Product Change Notification

Product Change #: PCN364

Parts Affected: NVFY42S-001

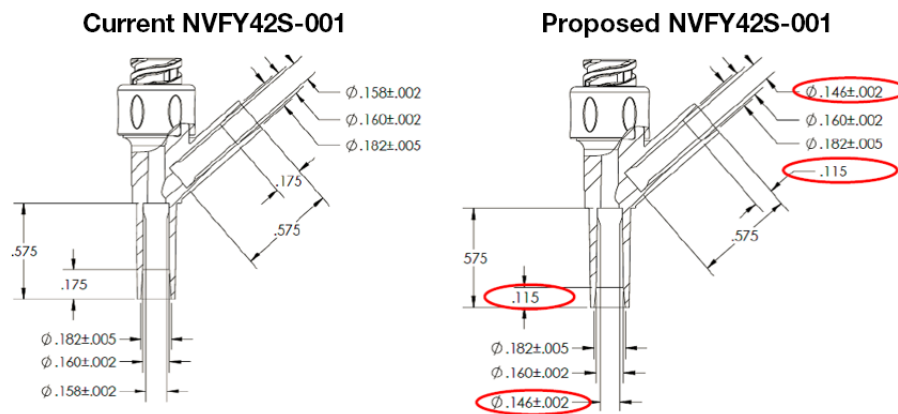
Changing port ID from .158" to .146" to accommodate 3.8mm tubing. Spec still accommodates tubing 3.8mm-4.1 mm this change tightens the fit to accommodate smaller OD tubing sizes.
